Re: Deck Replacement

606 Tower Bank Road

OFFICE OF PLANNING AND ZONING

CONFIRMATION OF PRE-FILE (2025-0073-P)

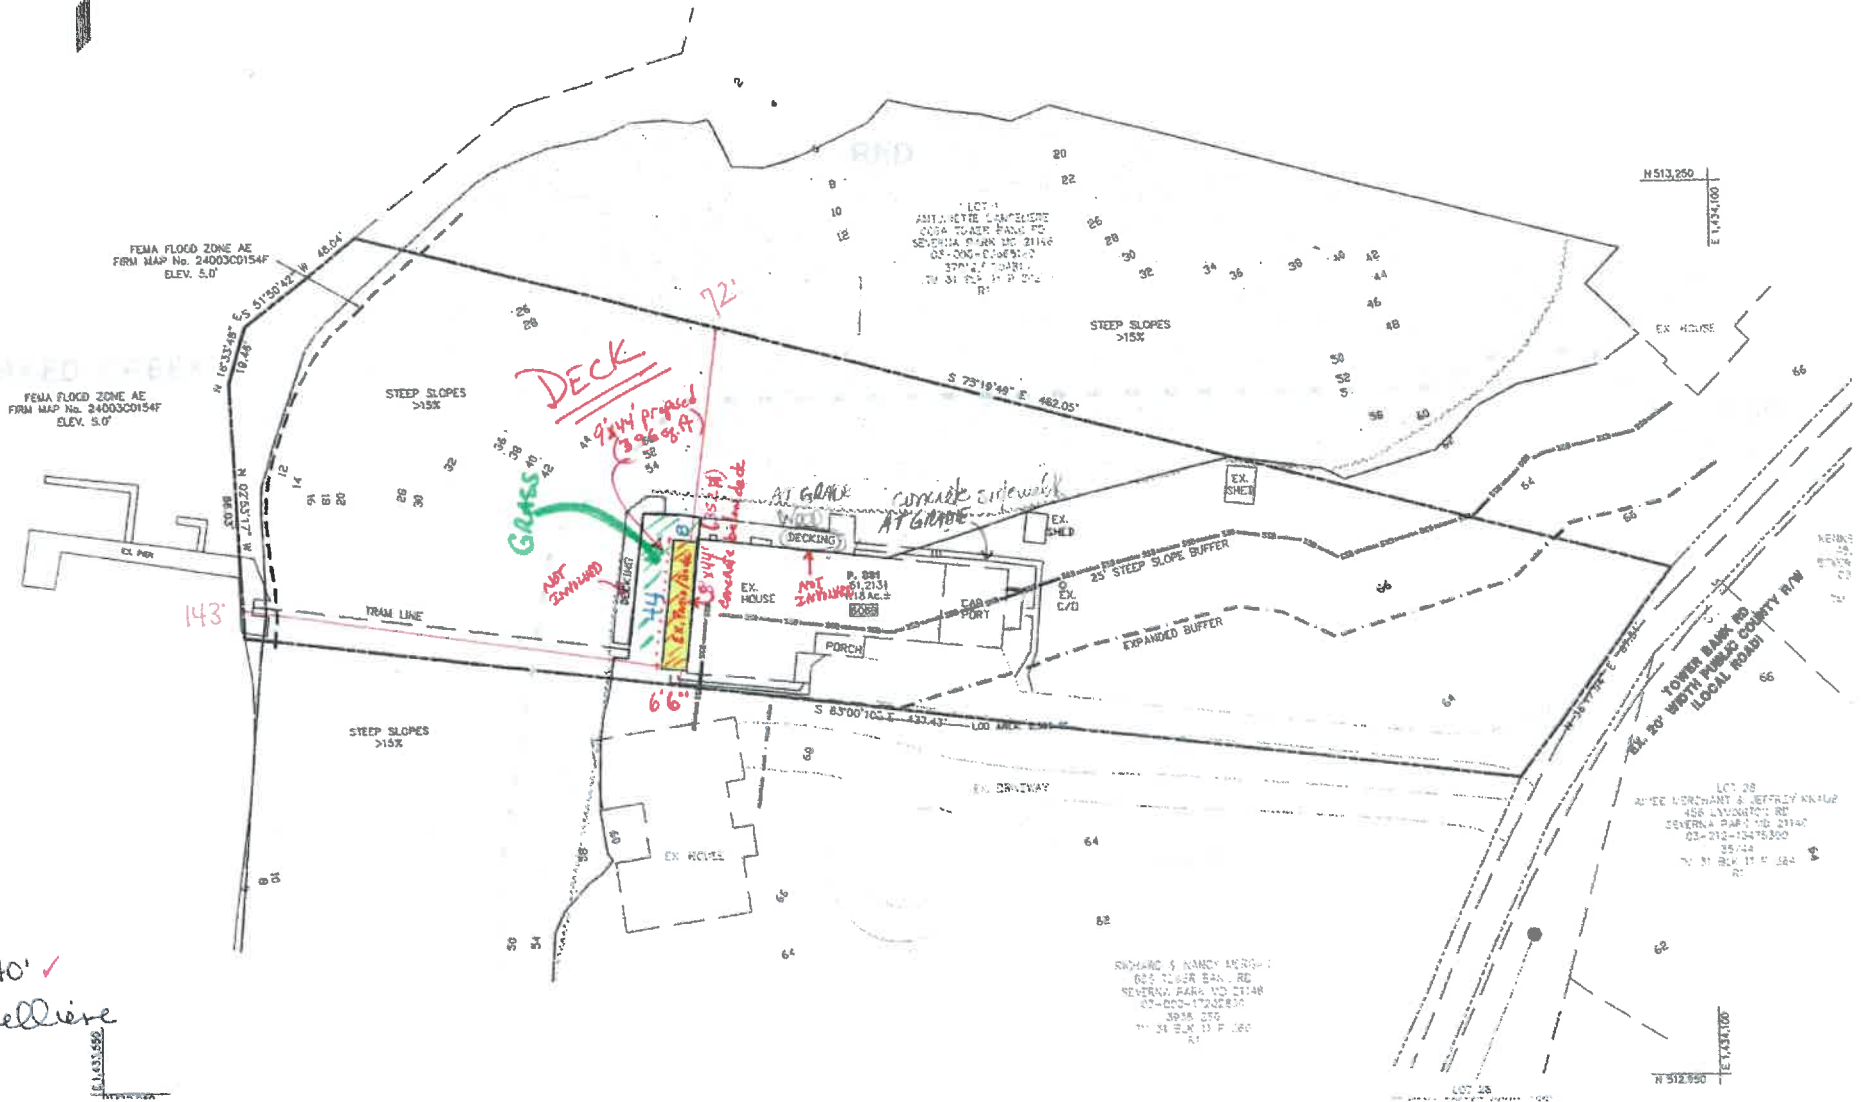
The **Zoning Administration Section** notes that the site plan is confusing and should be revised to show the entire deck area and to clarify the existing vs. the proposed deck (perhaps shown separately for clarification). The site plan must also label the deck dimensions, number of stories, and height of the proposed structure and must label the distance between the deck and the south side lot line. Finally, the site plan should show the Limit of Disturbance (LOD) around the proposed deck that is necessary for access during construction. The applicant is advised that, in order for the proposed Critical Area variance to be approved, the applicant must demonstrate and the Hearing Officer must find that the proposal complies with each and every one of the Critical Area variance standards provided under Section 18-16-305(b) and (c). Therefore, the letter of explanation should be amended to address the critical area variance standards.

- B.) All Variances for Article 18-16-305(c) and 18-16-305(b) have been addressed in an attachment
- C.) The site plan has been updated with the original deck in Yellow and the proposed 9x44' deck in Red

- D.) The measured distance to the South side is 6'6" from the left rear corner of the house. I am not asking to change this dimension as the deck will align with the house corner.

- E.) Plans are attached, printable at 40 scale on 11x17" paper showing the existing deck in Yellow, the proposed deck in Red and a second copy indicating all impervious surfaces in Blue.
